CERTIFICATE OF APPROPRIATENESS

Property: 1222 Columbia Street, Lot 17, Block 191, Houston Heights Subdivision. The property includes a historic 1,428 square foot house situated on a 6,600 square foot (50' x 132') interior lot.

Proposal: Alteration – Renewal of a COA to construct an addition that was granted August 14, 2013 and has expired. The scope of work previously approved remains unchanged.

SOUTH SIDE ELEVATION

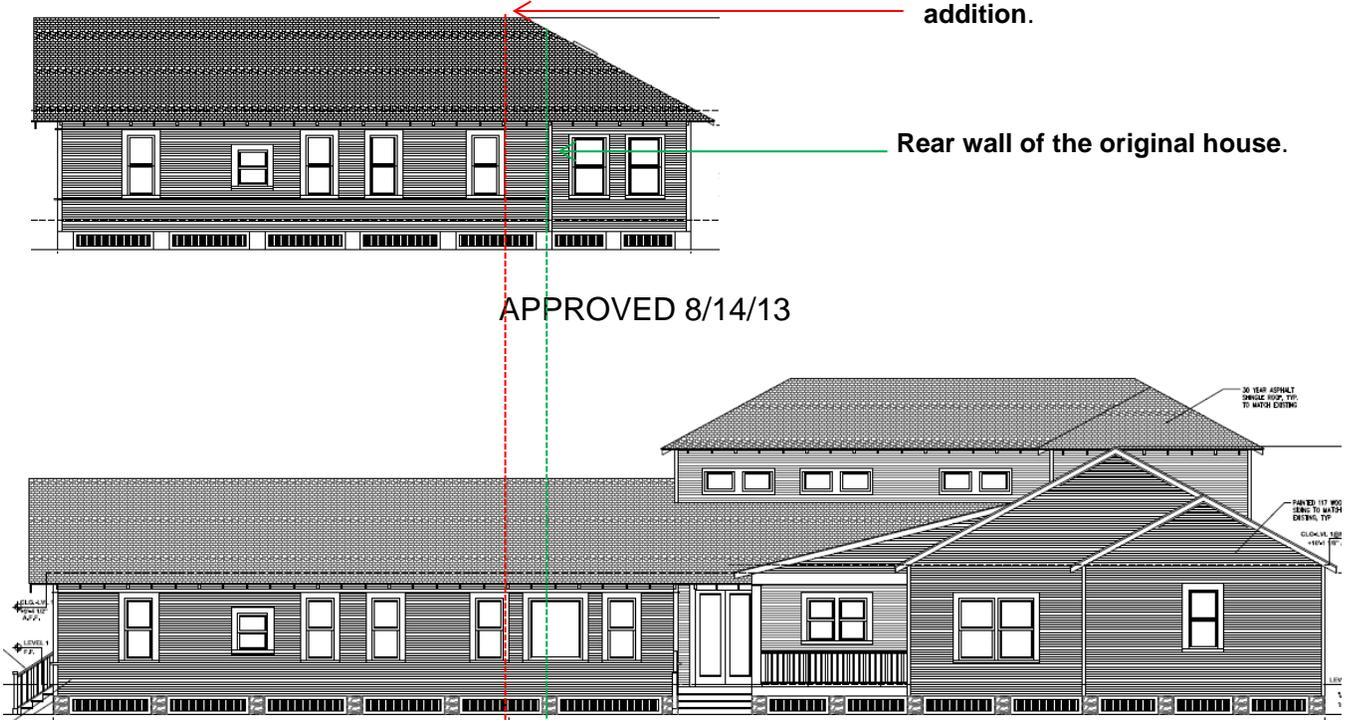
Starting point of the proposed addition.

Rear wall of the original house.

**Side Elevation:
(South)** The original 38' of the home will remain unchanged, with the exception of a small portion of the wall on the rear of the south elevation, which will be removed in order to accommodate the rear addition (see attached floor plans). An existing, non-original rear addition will also be removed. Approximately the first 14' of the addition will be one story and will be built under a roofline matching the existing house. The remaining 55' of the addition will consist of a two story portion

NORTH SIDE ELEVATION

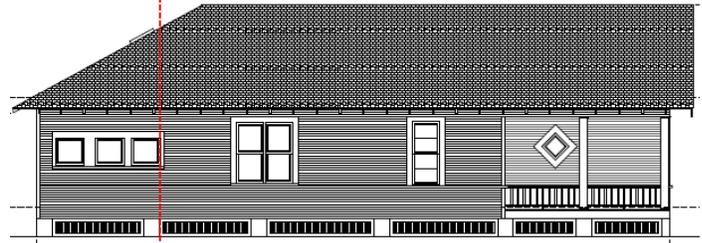
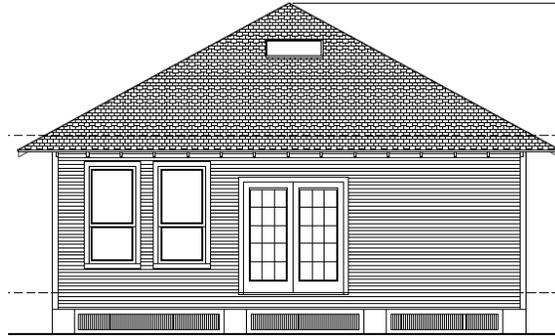
Existing aluminum window to be replaced with wood windows of the same size

Two existing windows to be replaced as part of a reconfiguration of the kitchen

**Side Elevation:
(North)** A non-original metal window will be removed and replaced with a new wood one. To the left of this window, a pair of double hung windows will be removed and replaced with a pair of smaller windows in order to accommodate a kitchen. The rear portion of the addition will be two stories. It will be built over a pier and beam foundation, with the exception of the very rear, which will be built on a concrete slab foundation for the alley loading garage.
